CITY OF ALBUQUERQUE

Re: Karsten Court (Kraemer Fields) (M14D012I)
Architect Stamp Date: 1-21-21, Revisions Date: to 4-6-21

The TCL submittal received 04-07-2021 is approved for Building Permit with. A copy of the stamped and signed plan will be needed for each of the building permit plans. Please keep the original to be used for certification of the site for final C.O. for Transportation.

KRAEMER FIELDS
 ARCHITECTURAL SITE PLAN
 2811 KARSTEN CT. SE: ALBUQUERQUE, NM
 PROJECT #1905

AS-1.0

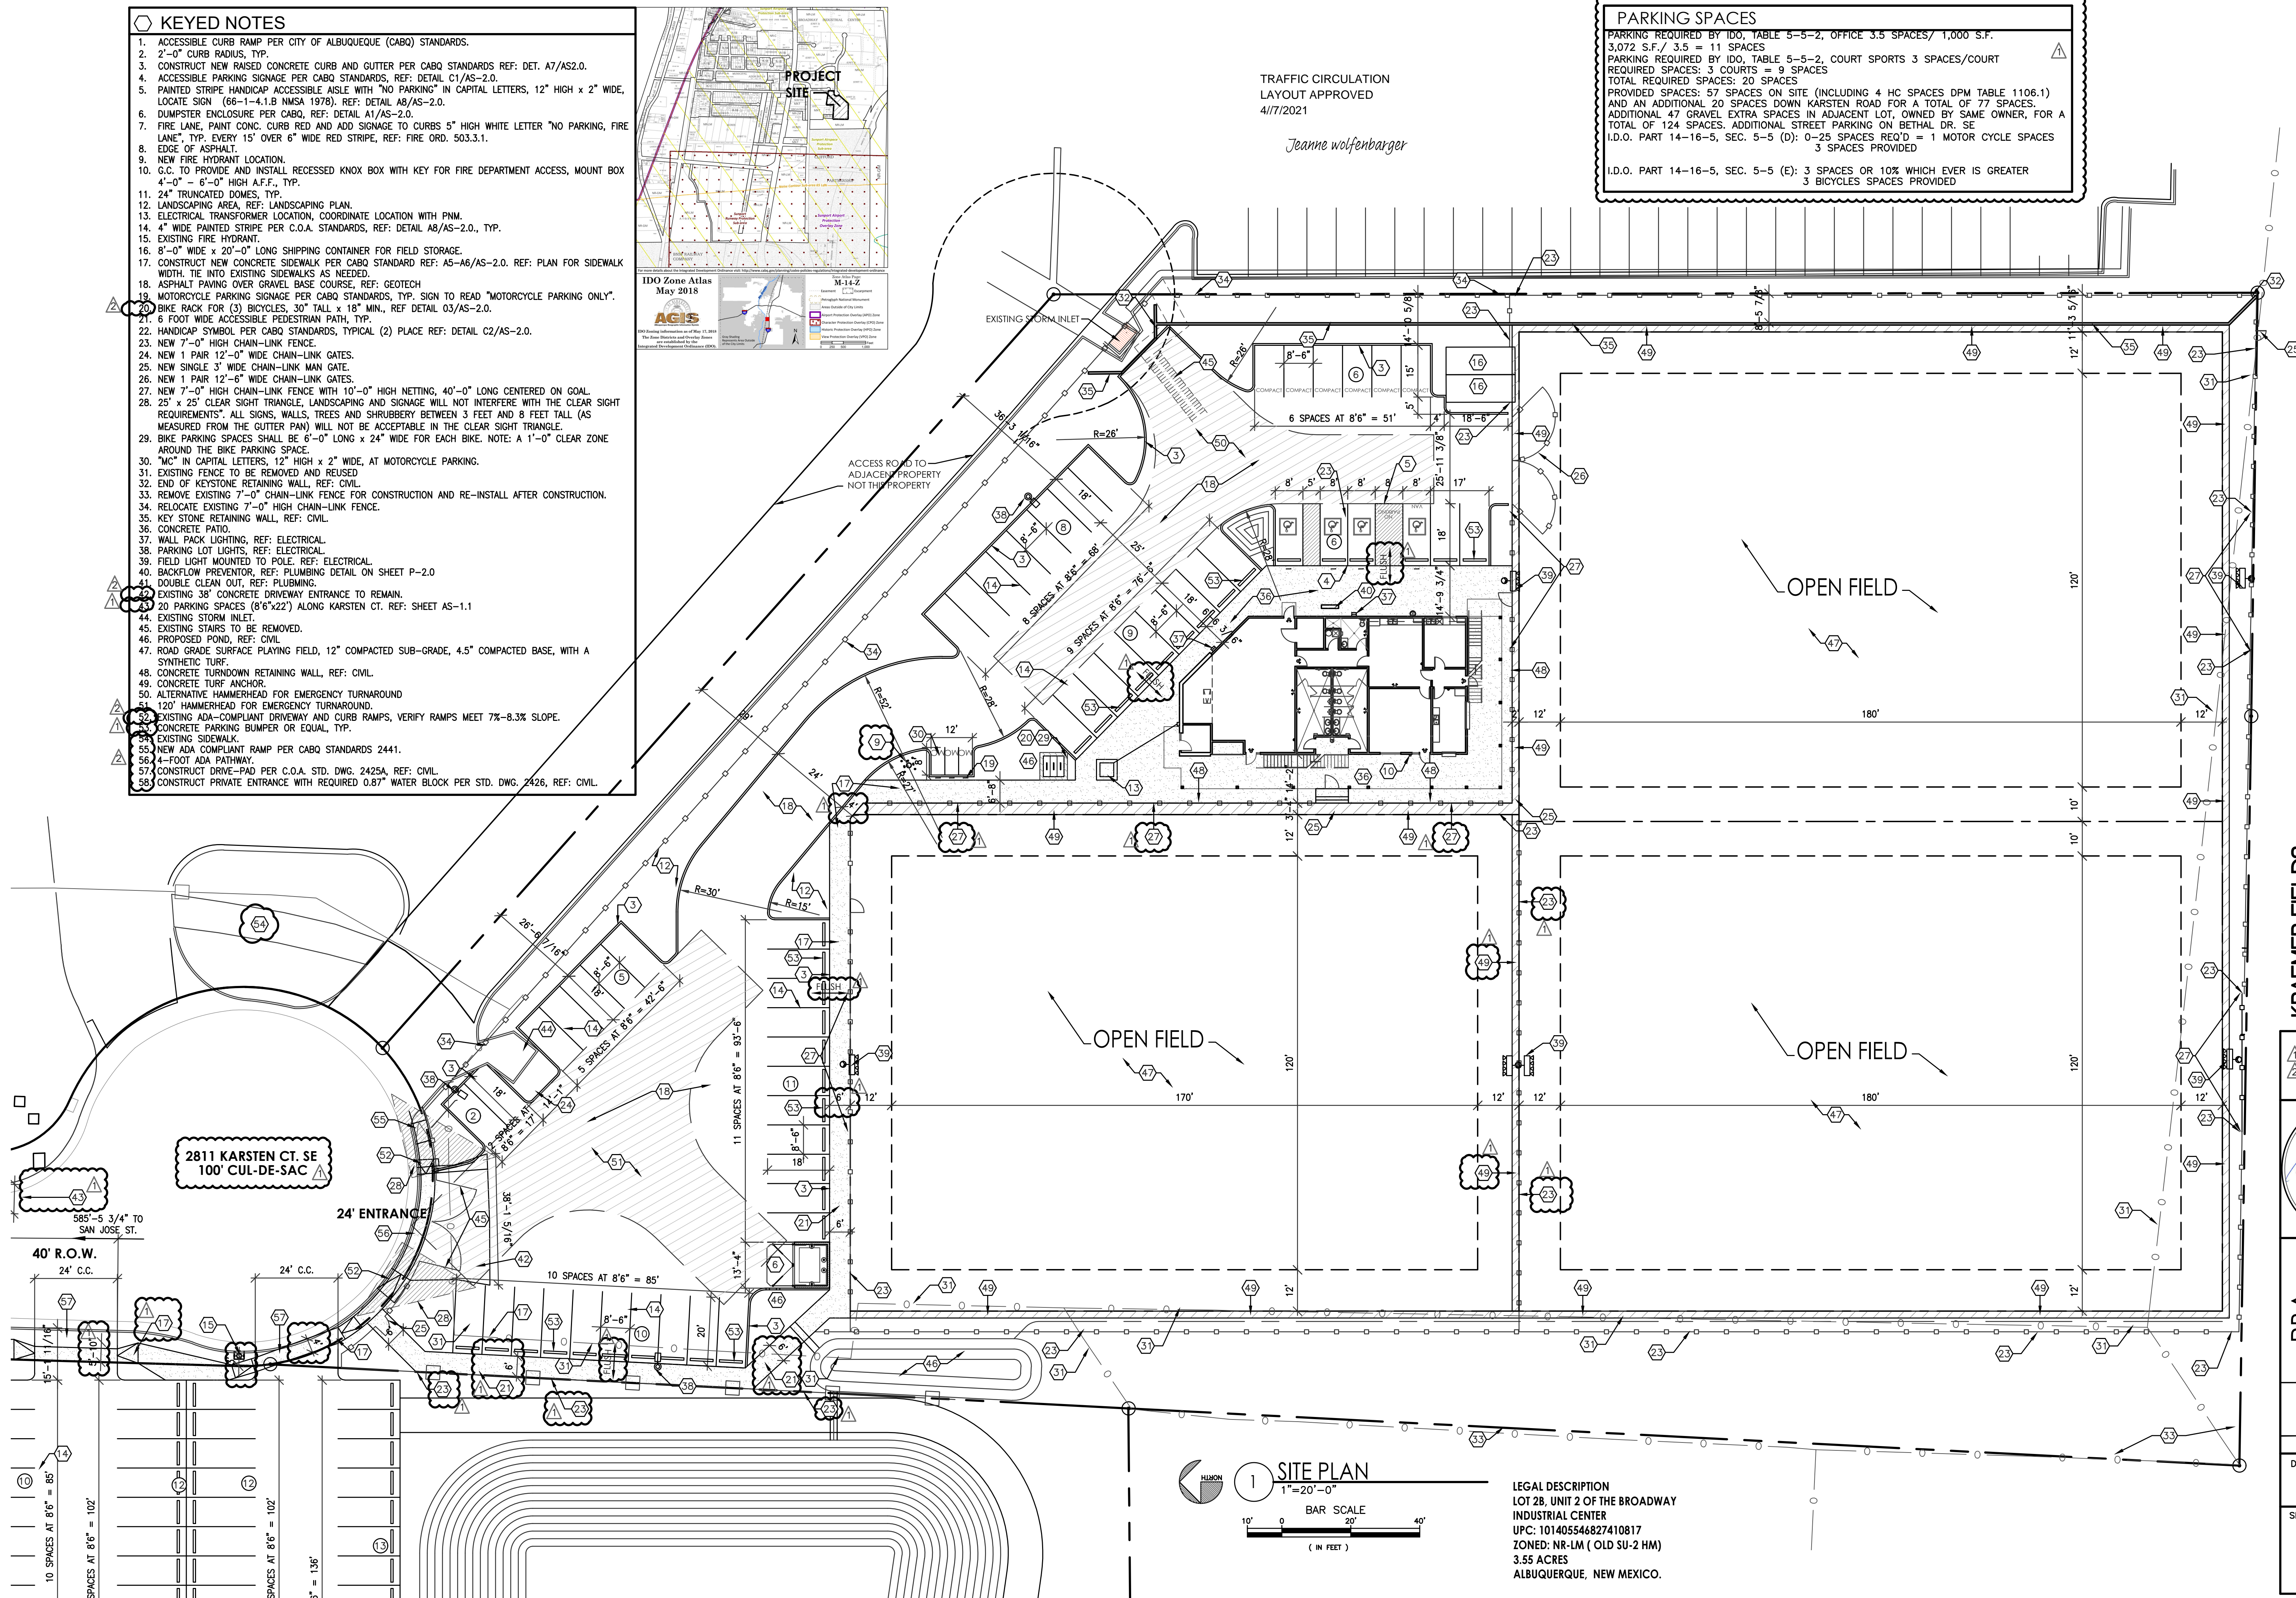
Include copy of approved Parking Agreement from Zoning Department prior to the Building Permit approval. Additionally, prior to Certificate of Occupancy, obtain a sidewalk easement for the minor sidewalk encroachment outside of right-of-way at the fire hydrant location.
